Record of Executive Business and Chief Executive's Order

Reg. Reference: SDZ22A/0011 **Application Date:** 02-Aug-2022
Submission Type: Significant **Registration Date:** 20-Jan-2023
Additional
Information

Location: Thomas Omer Way, Balgaddy, Lucan, Dublin

Figure 2.2.1 Street Hierarchy

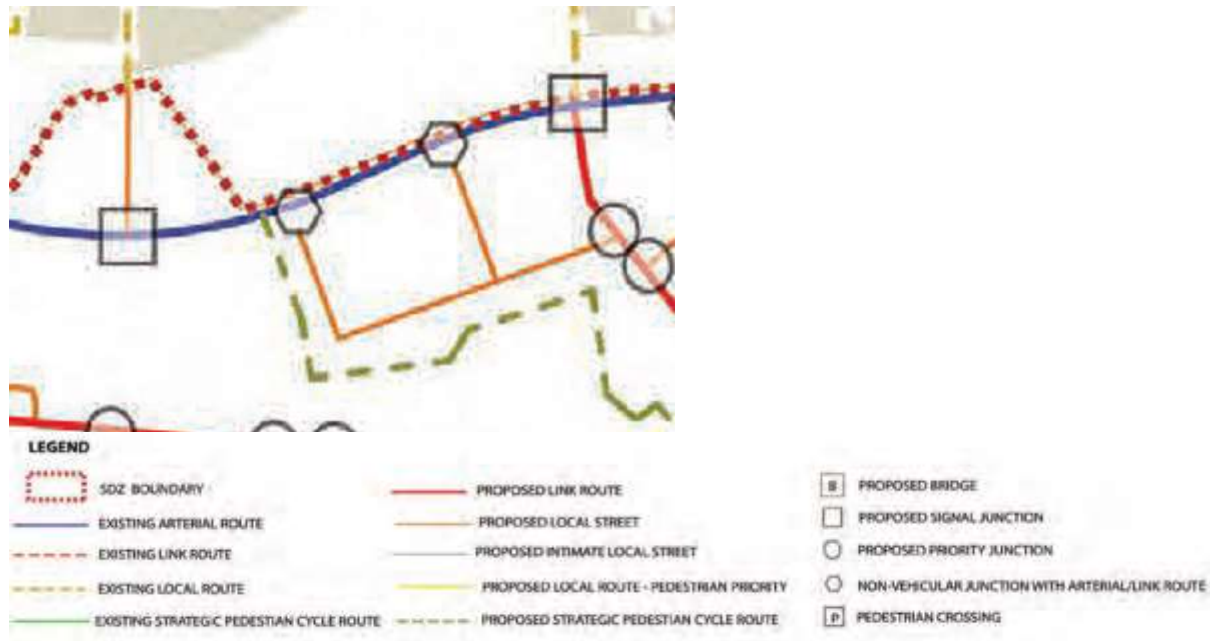
Having regard to the above, it is considered that the movement and street network proposed by the applicant is not consistent with the Planning Scheme in terms of an open permeability network and priority for cyclist and pedestrian movement.

The applicant is requested, via **additional information**, to re-examine the streets that they are proposing to deliver. There are concerns that the delivery of an element of the link street would be premature, as there are strategic infrastructure requirements linked to its delivery. It may be more feasible to provide a local street linking to Thomas Omer Way, either to the east of the proposed school, in link with figure 2.2.7 or to the west, linking up with the adjacent existing school site. It should be noted that the area to the west is also proposed as a green infrastructure link and any development in this location should be mindful of this designation.

In terms of street design, it is not apparent that the proposed streets are laid out in accordance with the requirements of the scheme, the applicant is therefore requested to re-design streets to ensure compliance with Figure 2.2.6 of the Planning Scheme (and Figure 2.2.5, if relevant).

Figure 1 link street.

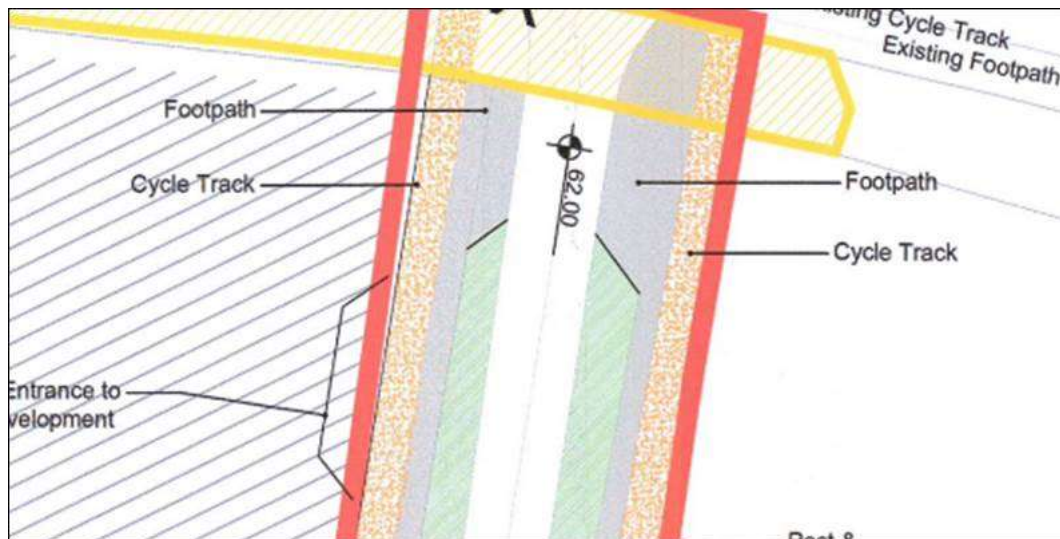
The entrance road should match the street layout as described in the SDZ, the cycle lanes and footpaths do not match the layout out for a link street. The cycle track is outside the footpath. No dimensions or cross section have been provided.

There is provision for future road connection to the south linking with the greater Clonburris developments. This road should be constructed in its entirety to the boundary to prevent ransom strips at a future date. Entrance locations to the future development area at the centre have been indicated although the southern potential access is located within the drop off area.
